A FLECK PERFORMANCE BULLETIN

Bulletin No. 341

2900 Lower Drive Cam Improvement

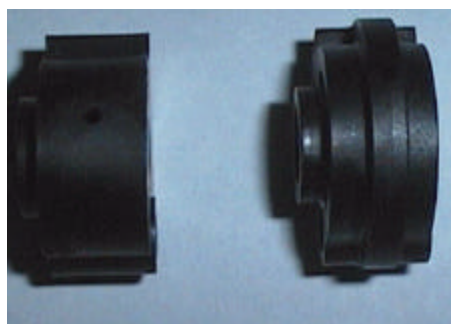
This new cam is stronger and has a molded hole for the connecting rod bearing. Having the molded hole, always in a fixed position, allows for a consistent alignment of the micro switches on the cam and increase product reliability. This change was implemented on May 1, 1999.

Part numbers: 28164 (ex 24214) 2900 Adaptor drive cam assembly
